DCN No. E990360-00-D

DOCUMENT CHANGE NOTICE (DCN)

DOCUMENT No. (DOC-REV-GP. ID)	TITLE	NEW REV.
D960138-02-D	Sensor/Actuator Head Assembly, LOS	A

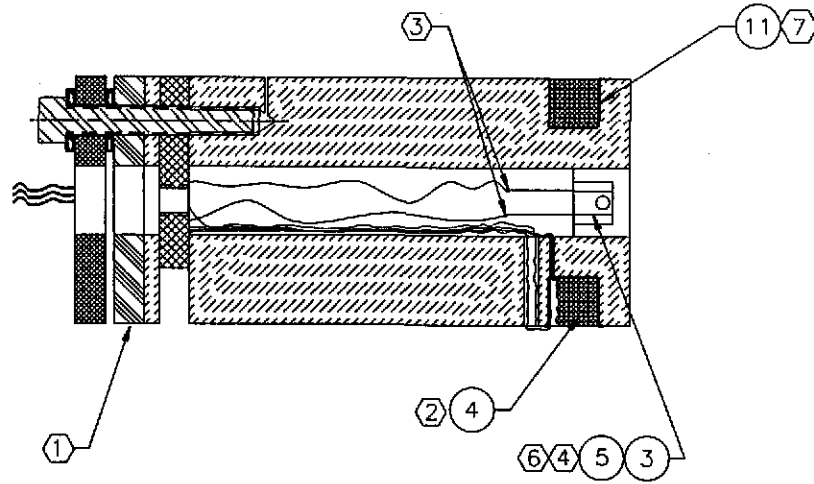
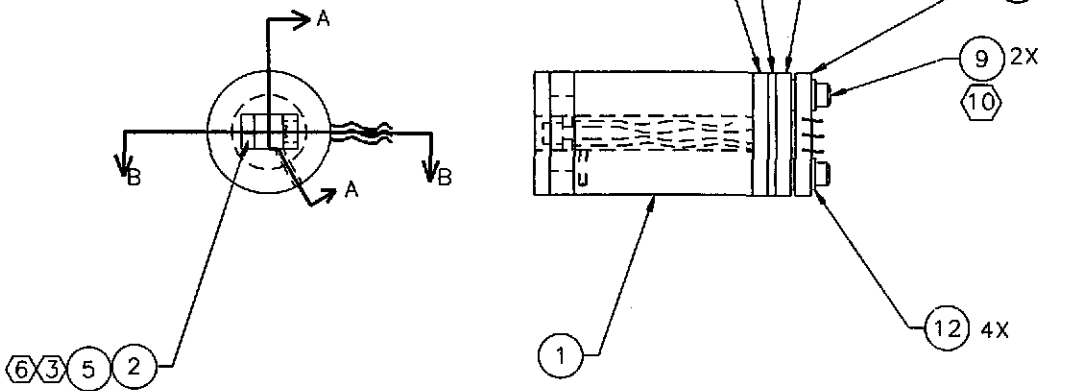
CHANGE DESCRIPTION (FROM/TO): Extensive changes for initial release. See rev 02 for "was" condition.

REASON FOR CHANGE: document as-built configuration

- ④ POSITION LED USING SPACER IN SENSOR/ACTUATOR HEAD. LED SHOULD FIT IN ARCH OF SENSOR/ACTUATOR HEAD SPACER.
- ⑤ WIND MAGNET WIRE AS TO FILL VOLUME AS SHOWN, 1.010 OD MAX.

- ⑥ BOND LED AND PHOTODIODE TO SENSOR ACTUATOR HEAD USING A MINIMUM OF VAC SEAL EPOXY.
- ⑦ POSITION PHOTODIODE FLUSH TO -A-.
- ⑧ APPLY ITEM 10, TEFLON TAPE, TO COVER THE INSIDE OF THE CHANNEL BEFORE WINDING THE MAGNET WIRE, ITEM 4.

- ⑨ ASSEMBLE THE SENSOR/ACTUATOR PIGTAIL, ITEM NOS. 13 OR 14, SUCH THAT THE PIGTAIL END IS OPPOSITE TO THE PHOTODIODE.
- ⑩ D990675 LONG PIGTAIL IS USED ON THE ETM, ITM, BS AND FM LOS SUSPENSIONS MOUNTED IN BSC CHAMBERS. D990676 SHORT PIGTAIL IS USED ON THE RM AND MMT3 LOS SUSPENSIONS MOUNTED IN HAM CHAMBERS.

- ⑪ DUE TO VARIATIONS IN THICKNESS OF THE BRACKETS, ITEM NOS. 6, 7, 8 AND 12, ITEM 10 MAY BE USED AS AN ALTERNATE TO ITEM 9.
